Work Order ID 85893

Item Name: 205 Skidtube bent detail

DRAWING NO. D2580	TITLE 205 SKIDTUBE ASSEMBLY	REV. E	DART AEROSPACE LTD ENGINEERING ORDER	D.E.O. NO. D2580-E-1	SHEET NO. SHEET 1 OF 1	SCALE NTS
DRAWN <i>UP</i>	CHECKED <i>ASS</i>	MFG. APPR. <i>EC</i>	APPROVED <i>[Signature]</i>	DE APPR. <i>[Signature]</i>		
DATE 11.12.13	DATE 11.12.13	DATE 11.12.13	DATE 11.12.13	DATE 11.12.13

CHANGE ALL C'BORED WELDED CROSSBOLT SPACERS TO SWAGED SPACERS

SECTION B-B, F-F, I-I
NOT TO SCALE

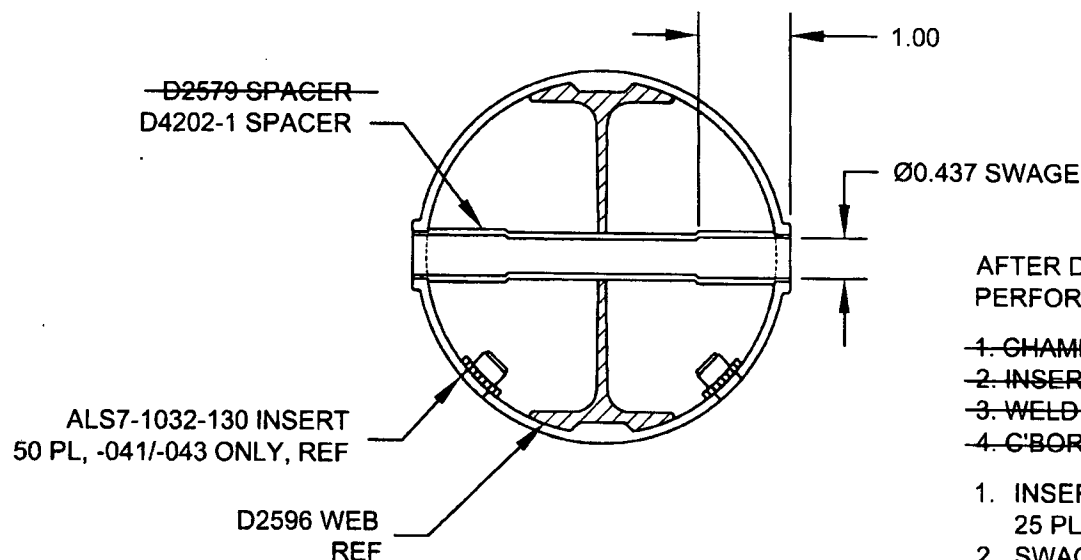
SECTION B-B, SECTION F-F, & SECTION I-I ARE AMENDED AS FOLLOWS
FOR ALL HOLES THAT WERE ORIGINALLY C'BORED:

- ~~1. CHAMFER HOLE 0.050 X 45°~~
- ~~2. INSERT D2579 SPACER (20 PLACES)~~
- ~~3. WELD INTO PLACE AND GRIND FLUSH~~
- ~~4. C'BORE D2579 SPACER TO Ø0.437 X 1.00 DEEP~~

WELD 4X D2579 SPACERS PER DWG
IN LOCATIONS MARKED "NO C'BORE".
REF SHEET 4 OF DWG.

1. INSERT D4202-1 SPACER, 20 PL (-041) OR 20 PL (-045) OR 25 PL (-047)
2. SWAGE TO Ø0.437 X 1.00 DEEP PER QSI 002
3. TRIM / GRIND FLUSH PER QSI 002
